Technical Information

Big Room Air Conditioner

Subject : Big Rac Communication Error (F27-01)

a. Units Installed With Isolator Switch

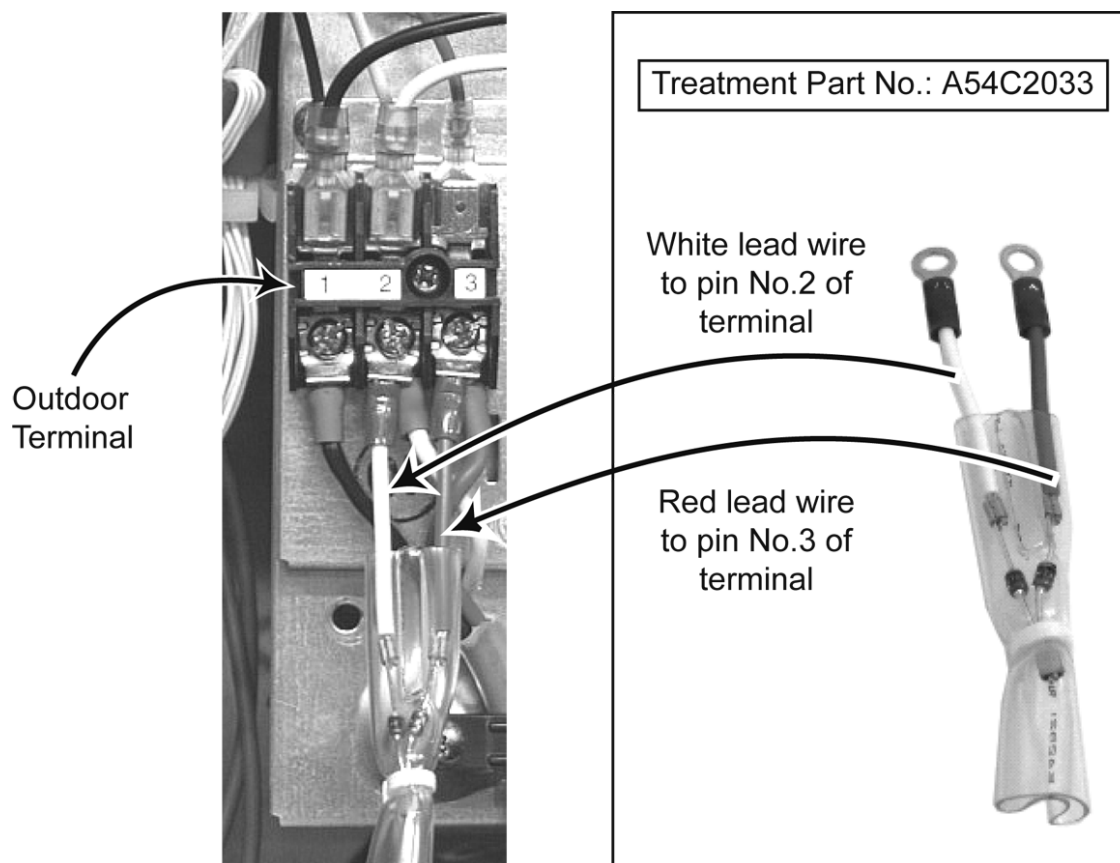
The damage to the outdoor PCB's communication line (F27-01) is due to the transient voltage passing through the communication line as a result of which a Life line (pole) being turned ON first and a Neutral line (pole) being turned ON later.

- Connect the market treatment part (Code No.:A54C2033) to the outdoor unit communication terminal (between No.2-pin and No.3-pin).
- The treatment part should be tightened together with the indoor-outdoor communication cable.
- Connect the treatment part's white lead wire to No.2-pin of the terminal, and the treatment's part red lead wire to No.3-pin of the terminal.
